Sunrise Powerlink Transmission Project

PROJECT MEMORANDUM

Date: September 2010
To: Interested Parties
From: California Public Utilities Commission and Bureau of Land Management
Subject: Sunrise Powerlink Project Modifications Report

Final PMR Route
Overhead Portion
Fire Behavior Trend Model
4 Burn Periods - Extreme Weather

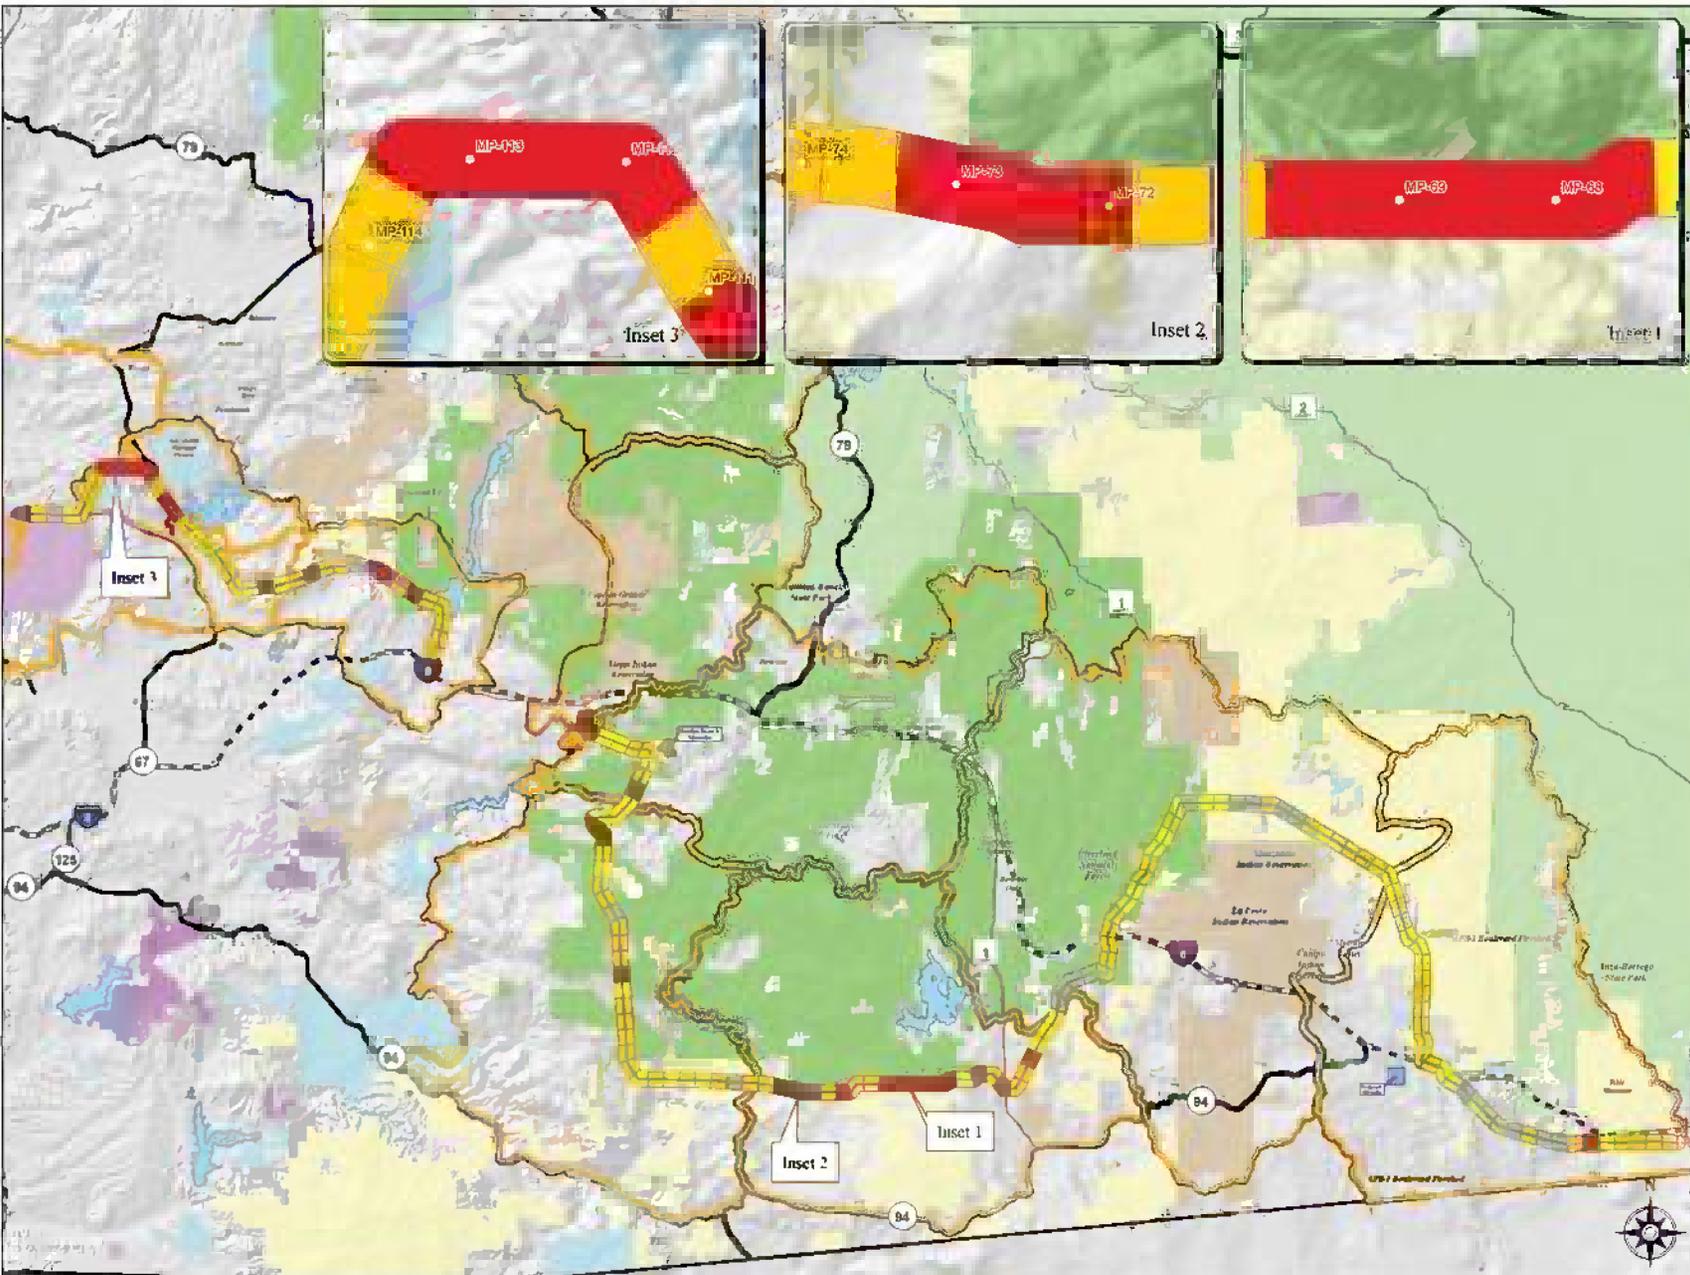
Wildfire Risk. In accordance with the County's suggestion to update the Fire Behavior Trend Model and the homes at risk calculation, the EIR/EIS Team reprocessed both the Fire Behavior Trend Model and the Wildfire Containment Conflict Model, and tallied the number of homes at risk and the number of significant miles of conflict for the project modifications. The number of homes at risk for the project modifications increased from 1,382 homes, as presented in the Final EIR for the FESSR, to 1,409 homes. This 2 percent increase in the number of homes at risk is within the margin of error of the Fire Behavior Trend Model (+/- 2 to 3 percent), and does not result in an actual increase in the absolute number of homes at risk. This increase is consistent with the Final EIR/EIS results.

The Fire Behavior Trend Model used in the EIR/EIS considers a worst-case-scenario of impacts, and the number of homes at risk as modeled for the modified route does not represent an increase in an existing significant impact or a new significant impact of the FESSR, and validates the results from the Final EIR/EIS. In order to err on the side of increased safety for residents in the vicinity of the modified route, the higher number of homes at risk (1,409) will be used to calculate the total annual value of the Defensible Space Grants Fund per Mitigation Measure F-1e. Damage or loss of the 1,409 homes at highest risk in the event of a wildfire resulting from the Sunrise Powerlink project will therefore be partially mitigated by implementation of Mitigation Measure F-1e, the Defensible Space Grants Fund, which will ensure defensible space and fire-safe structural improvements to those homes at highest risk,
